**DEVELOPMENT SERVICES COMMITTEE
PART A**

FILE NUMBER SC 10-112600

9442 HIGHWAY 48

PROPOSED MINTROCK DEVELOPMENT

Proposed Site Plan

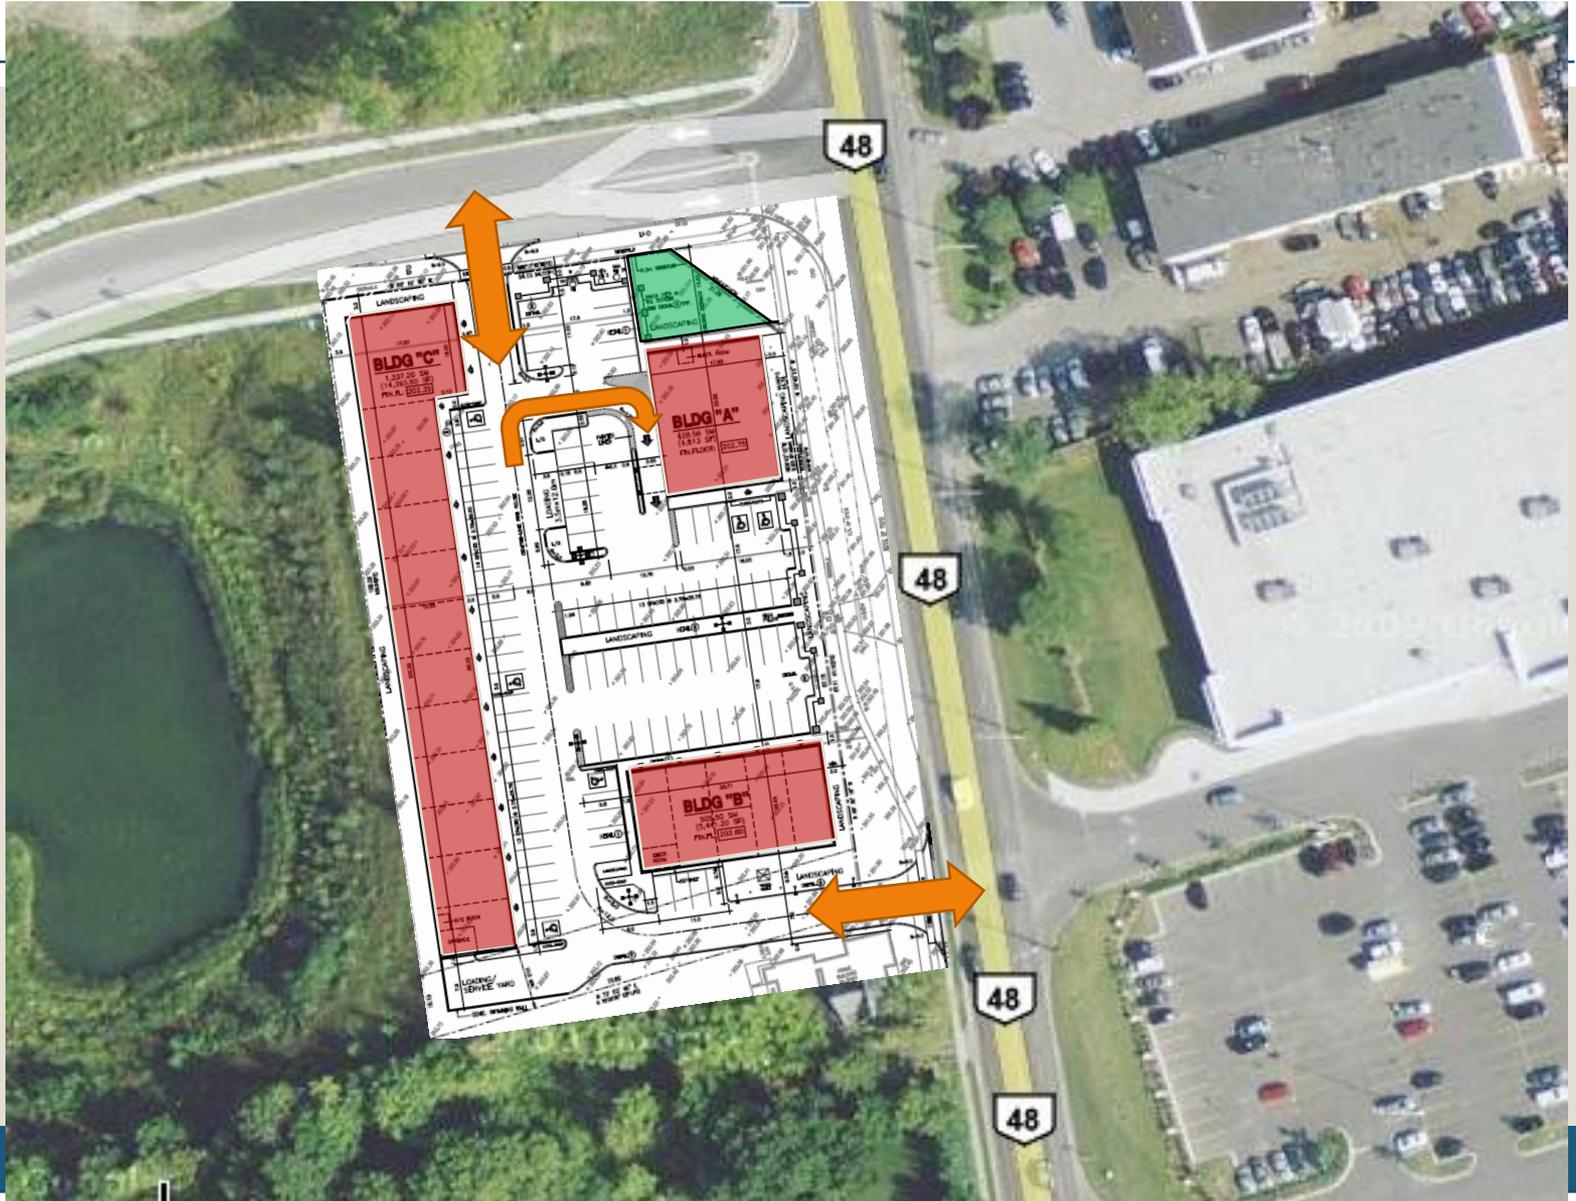
- Appropriate alignment of the driveway accesses with adjacent properties (No Frills and Anagni)
- Possible right-in/right-out restrictions for both access points
- Appropriate built form and elevations having regard for:
 - Highway 48 Urban Design Study
 - Prominence of the Highway 48 frontage
 - Height and architectural elements need further refinement
 - Parking and landscaping
 - Dividing the building mass at the rear of the property
 - Zoning bylaw compliance
- Signage compliance

- Staff request Committee delegate site plan endorsement and approval to Staff over the summer recess, subject to acceptable plans.
- Applicant to work with staff to better reflect the Urban Design Guidelines for the area.
